Integrated Issue Resolution Status Report

**U.S. Nuclear Regulatory Commission
Office of Nuclear Materials Safety and Safeguards
Washington, DC 20555-0001**

Manuscript Completed: April 2002

J. W. Andersen, NRC Project Manager

Figure 2.1.6-3. Modified DOE Preclosure Classification Criteria⁹

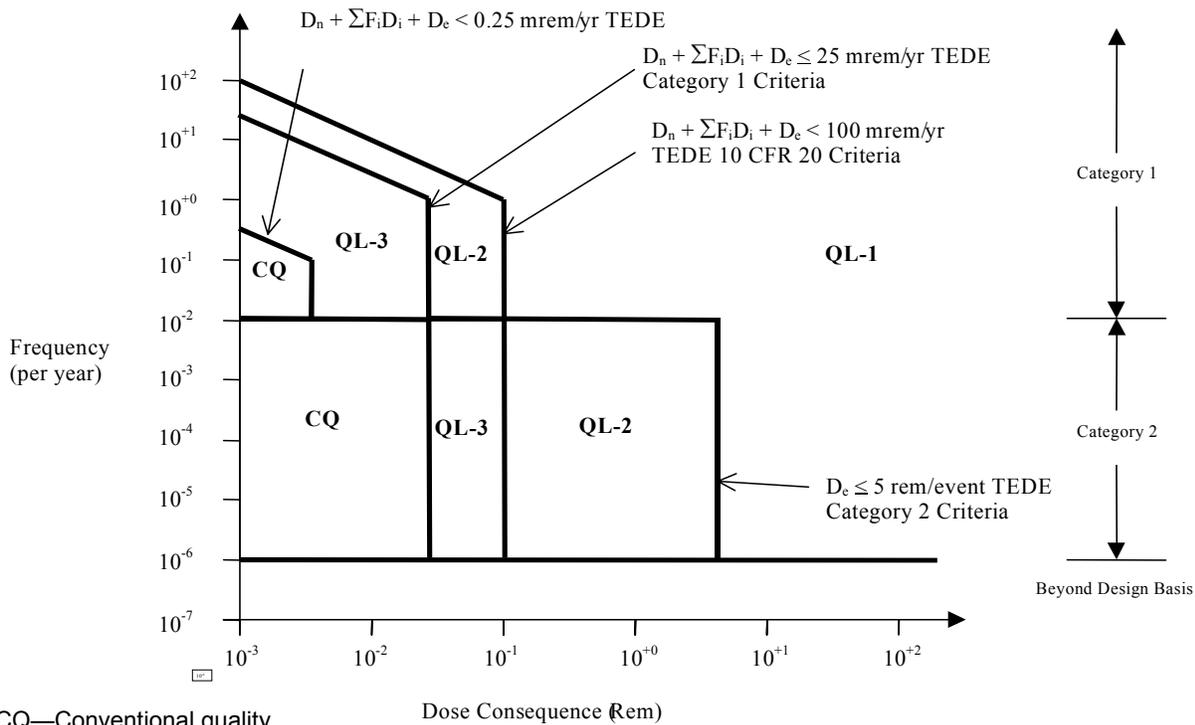
release in the annualized dose expression and also shows the risk measures for Quality Levels 2 and 3 and conventional quality for Categories 1 and 2 event sequences. DOE stated it is revising the procedure QAP-2-3 (CRWMS M&O, 1999c) and developing a desktop reference that will provide a clear description of the categorization process, screening criteria, and take-away analysis. Staff agreed with the overall DOE approach to categorize structures, systems, and components important to safety. Staff will review the revised procedure QAP-2-3 and the desktop reference document when it becomes available.

Figure 2.1.6-4. Overview of the DOE Proposed Classification Process¹²

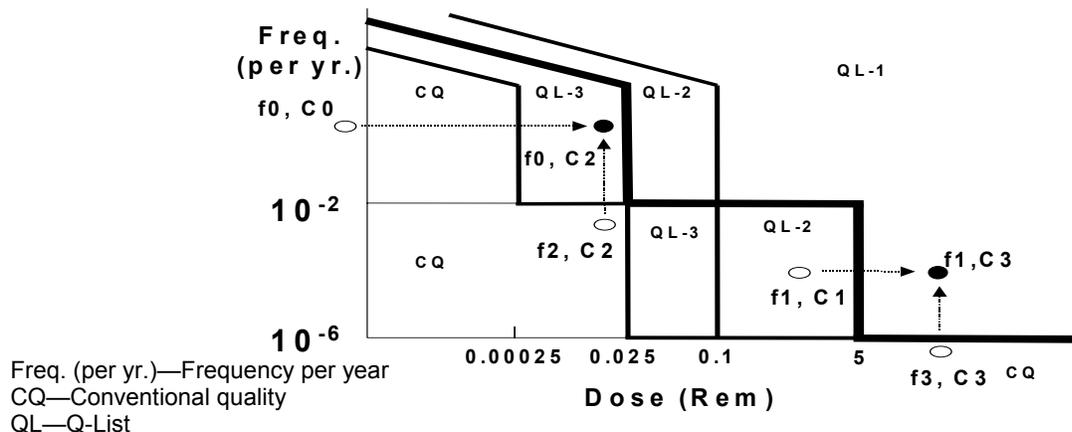
(CRWMS M&O, 2000c). It is unclear what consequence analysis assumptions are used in those take-away analyses that result in crossing frequency thresholds for event sequence categorization. For example, the end state (f_0, C_0) should not map to the end state (f_0, C_2) when structure, system, or component A fails, as indicated on Slide 12¹¹ and shown in Figure 2.1.6-4, because C_0 would be calculated with best-estimate parameter values, and C_2 would be calculated with bounding parameter values. In addition, f_3 represented a frequency below the lowest frequency for event sequence categorization for which consequences have not been calculated (CRWMS M&O, 2000c). It is, therefore, unknown what parameter value assumptions would be used for calculating the consequence denoted by C_3 . These issues will be discussed with DOE in a future technical exchange.

The DOE Q-List (2000) does not include all structures, systems, and components used in the geologic repository operations area. The DOE Q-List of structures, systems, and components and quality level characterization are based on the current system design described in several system description documents. 10 CFR 63.112 requires that the preclosure safety analysis of the geologic repository operations area identify those structures, systems, and components important to safety and also identify controls relied on to prevent potential event sequences or mitigate their consequences. DOE should consider all structures, systems, and components used in the geologic repository operations area to identify those important to safety. For example, shield doors and isolation doors, described in assembly transfer, canister transfer, disposal container handling and subsurface facility system description documents (CRWMS M&O 2000d–g), are not included in the Q-List. DOE should provide acceptable justification for

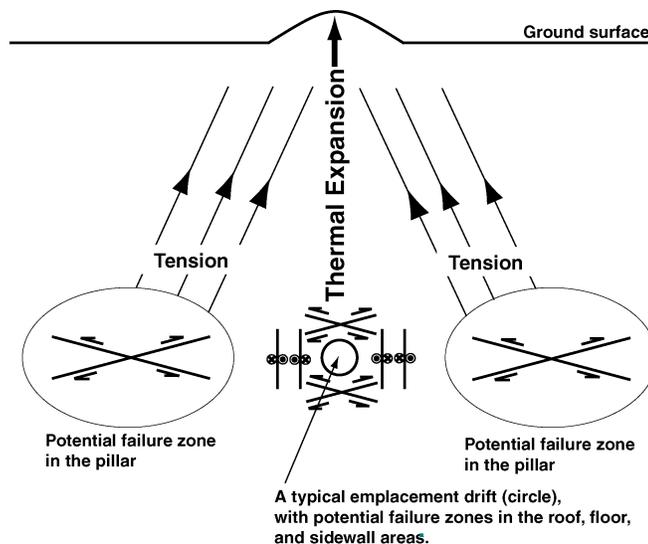
As illustrated in Figure 2.1.7-1 (Ofoegbu, 2001) and discussed in the foregoing paragraph, the effect of geometry on thermally induced stress depends to a large extent on the location of a mechanically free boundary, such as the ground surface. The topography of Yucca Mountain (e.g., Section 2.1.1) is such that the distance to the closest free surface and the orientation of the direct line from an emplacement drift to the free surface vary over the proposed emplacement area. For example, a typical east-west vertical section through Yucca Mountain (e.g., DOE, 2001a, Figure 1-10) indicates that the direct line from the emplacement area to the closest free surface would be inclined approximately 45 degrees to the vertical in the west (where the closest free surface is the Solitario Canyon) but would be nearly vertical in the east. Therefore, the orientation of the thermally induced tension in Figure 2.1.7-1 would vary over the emplacement area. For this reason, the topography of Yucca Mountain may have an important effect on the distributions of thermally induced stress and potential failure zones within the proposed emplacement area.

proposed drift alignment (252° azimuth, that is S72 °W). The ambient minimum principal stress is horizontal and oriented N60 °W–N65 °W (Stock, et al., 1985), which is 40–45 degrees from the drift-normal plane (the assumed orientation of the minimum principal stress for the two-dimensional modeling). Also, the dip direction of the subhorizontal fractures, which are likely to dominate the rock-failure mechanism as illustrated in Figure 2.1.7-1 (Ofoegbu, 2001), lies in the 40–60-degree range (i.e., 10–30 ° from the drift orientation). Therefore, the two-dimensional models are not favorably oriented to detect slip on the subhorizontal fractures. Three-dimensional modeling may be necessary to determine the effects of these structural features that are oblique to the drift alignment.

Other areas for which three-dimensional modeling may also be necessary include (i) stability of the turnout area (between the emplacement drifts and the access mains), which may be subjected to a combination of vertical tension and high-horizontal compression similar to the phenomenon illustrated in Figure 2.1.7-1 (Ofoegbu, 2001); (ii) effects of greater heat conduction rates through the drift floor because steel members in the floor (invert and pallet) that are in direct or indirect contact with the waste package provide a faster heat-flow path into the rock; (iii) stability of the structural components of the invert (transverse and longitudinal beams) and the interaction of the transverse beams with the drift wall under heated conditions; and (iv) effects of ground-surface topography drift-parallel thermal gradients on thermal stress and, consequently, drift stability. DOE has agreed⁸ to address this concern.
